# Access Compliance Report

## Public Rights-of-Way

### (Curb Ramps)

Intersection ID: 10038417	Main Street: SOUTH_REA_PARK_LN	Cross Street: N/A	Location: S
ADA ID: 7E444EB79538	Ramp Type: Perp	Initial Pass/Fail: Fail	Overall Compliance: No
Severity Score: 12.5			
Codes/Mitigation Info/Possible Solution		Field Measurements/Component Compliance

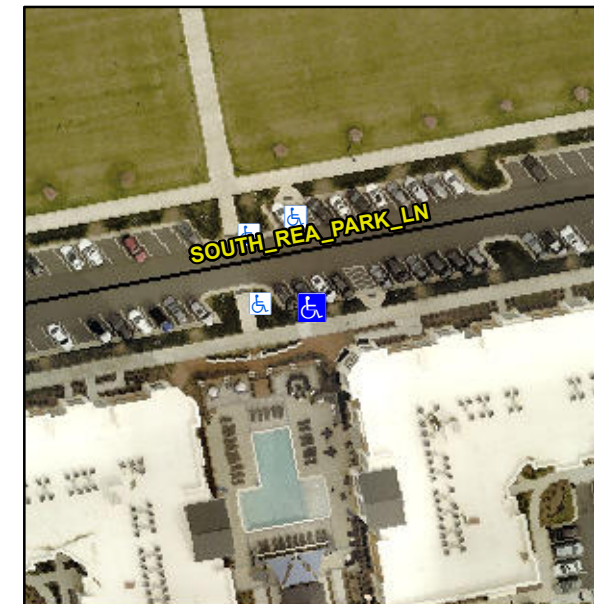
**Remove & Replace Entire Ramp.**

**Not Found, R304.2.2**
